BURLINGTON DEVELOPMENT REVIEW BOARD Tuesday December 4th, 2018, 5:00 PM Contois Auditorium, City Hall, 149 Church St, Burlington, VT AGENDA

TO: Development Review Board
FROM: Ryan Morrison
DATE: December 4, 2018
RE: 19-0416CA; 1 King Street

Request: Relocation of the existing loading ramps.

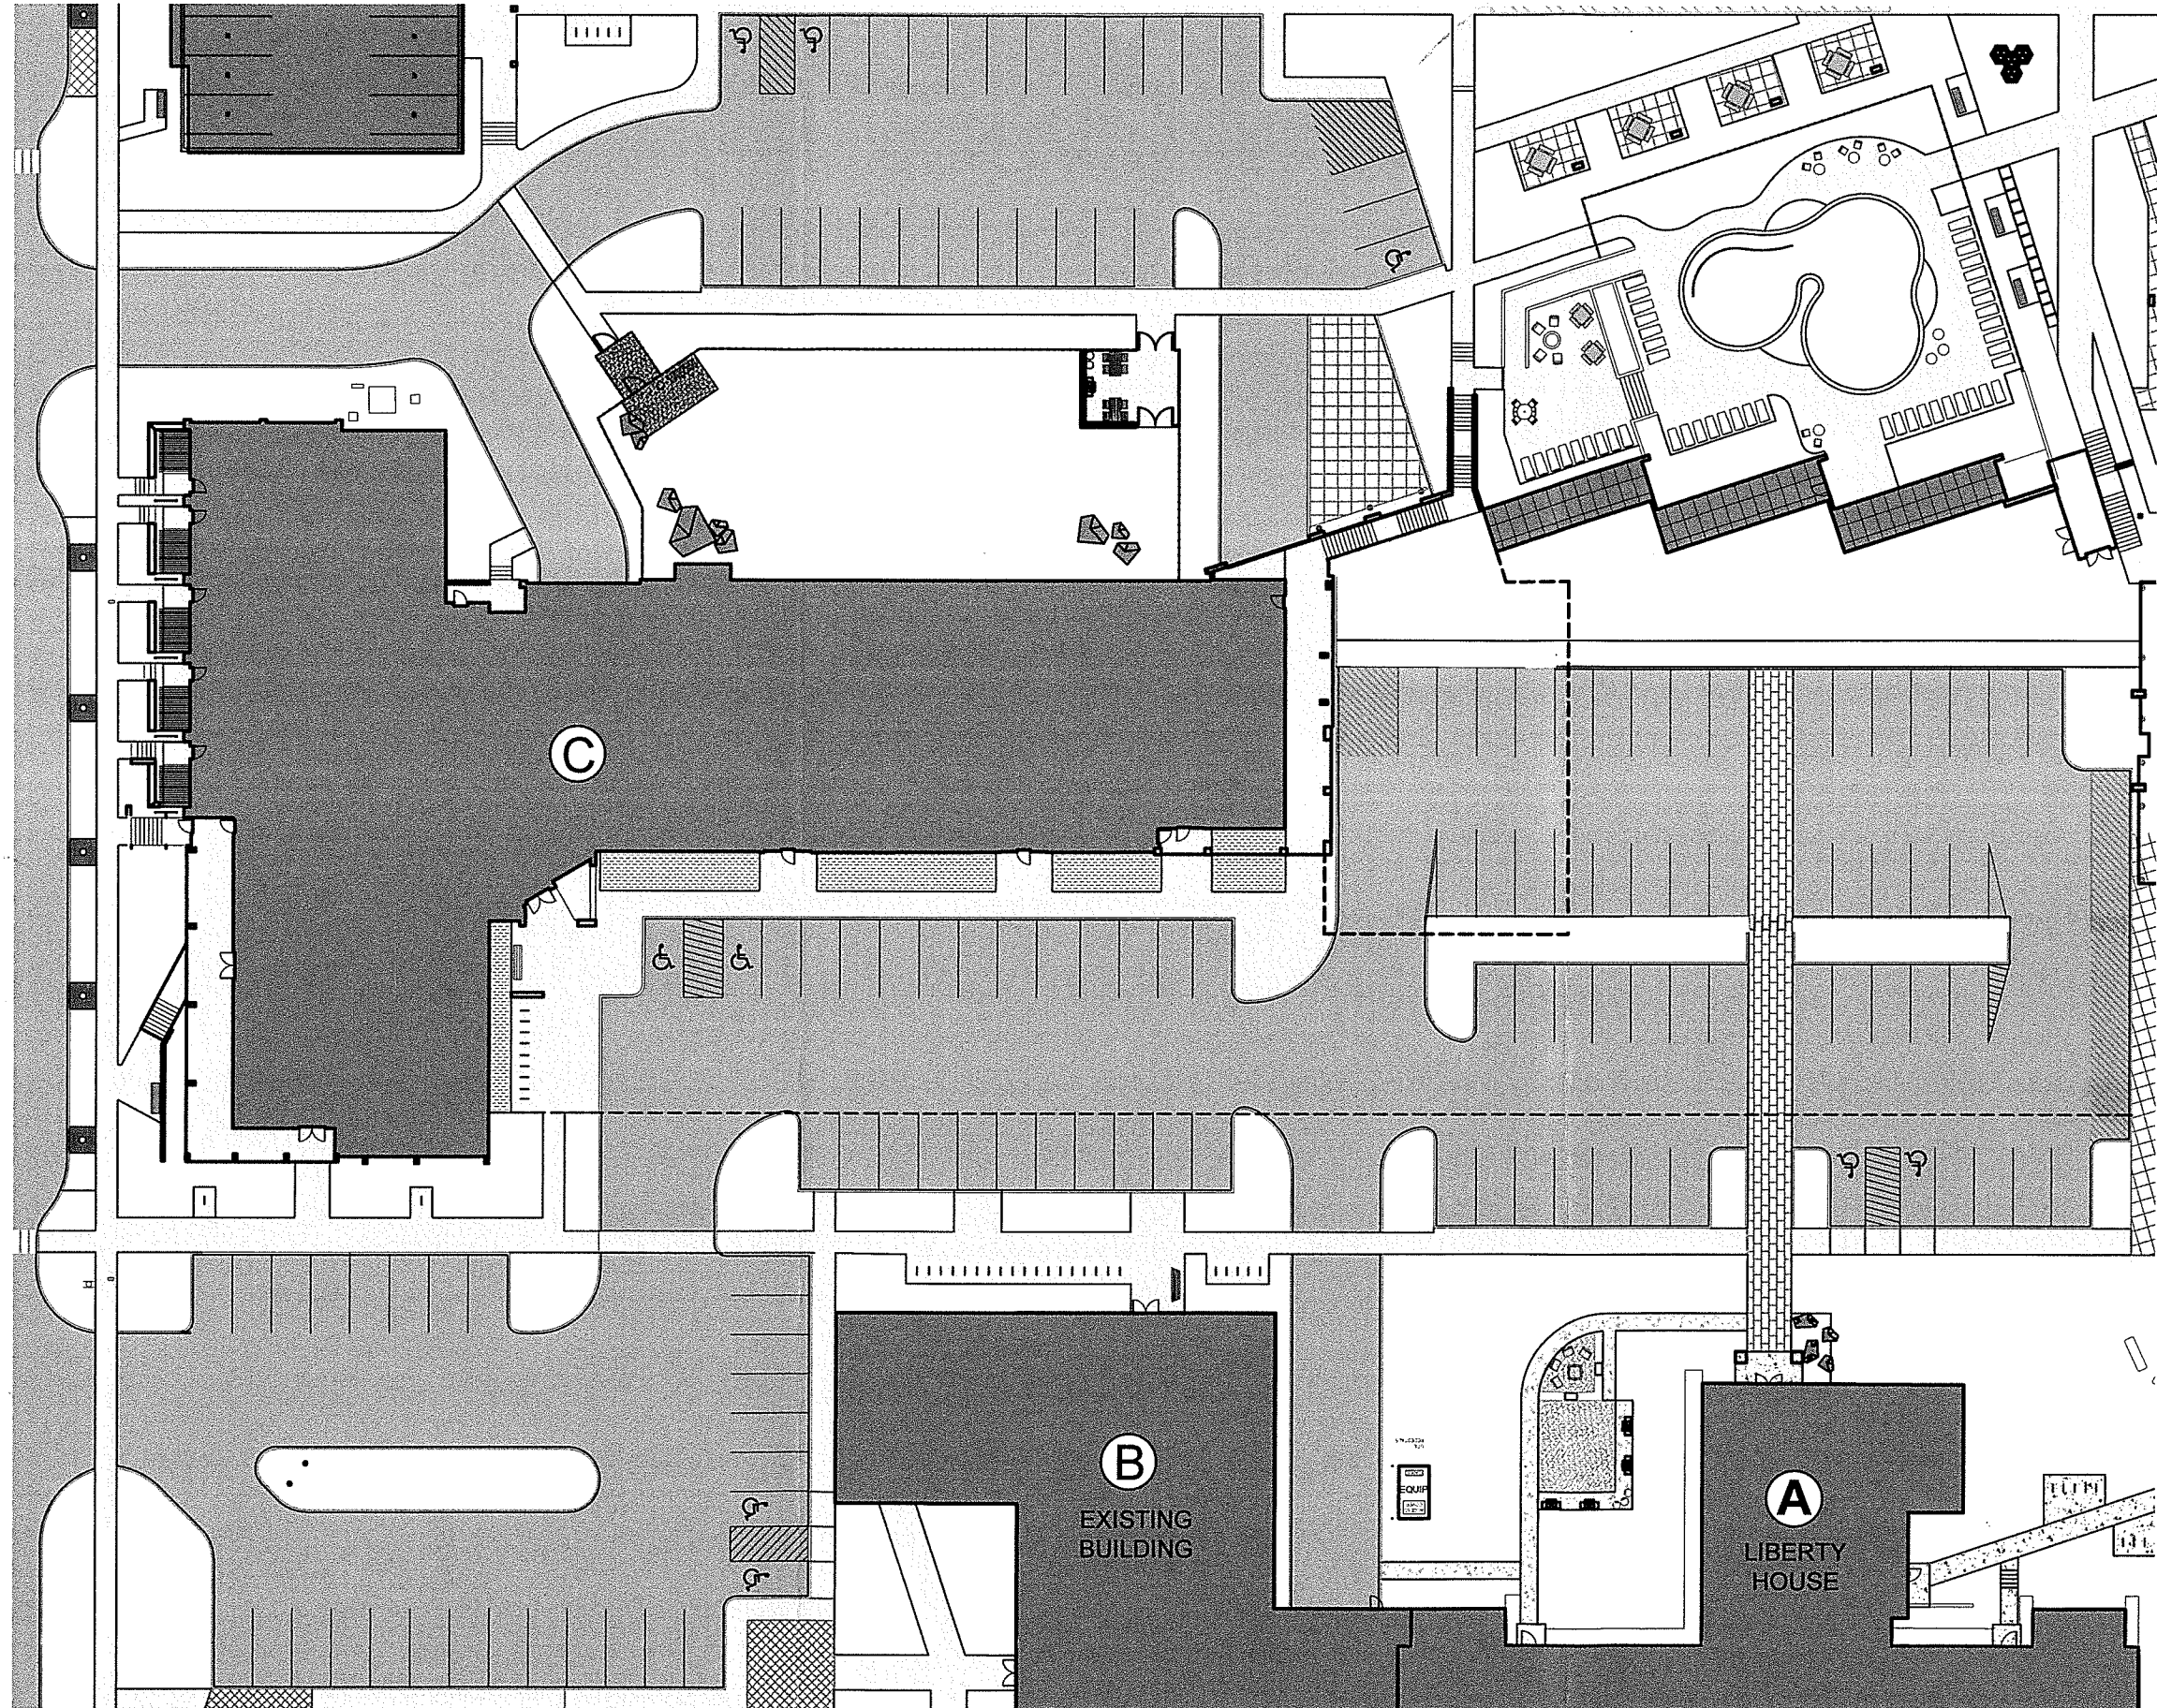
The proposed revisions to building C support the stature and presence of the prominent place it occupies on South Road/Cambrian Way. The street level glazing at the northeast corner is proposed to be modified with a timber panel system, eliminating the opportunity to view the interior of this identified commercial space. (Floor plans define relocation of bathrooms at this

location, informing that choice.) It is preferable that all commercial uses have visual access to the interior. *Non-residential buildings should provide visual access into the interior of building at the street level through the use of large transparent windows and/or window displays in order to create a dynamic and engaging public streetscape.* Although not a streetfront, the intended pedestrian circulation and proposed commercial use would benefit from clear shopfront glass on this first floor location, with bathrooms relocated to an interior space. **Affirmative finding if conditioned.**

1. It is recommended that the northeast corner first floor shall retain the previously approved plan of broad glazing to ensure visual access into the interior of the building, in order to create a dynamic and engaging public streetscape. (Section 6.3.2 (d).)
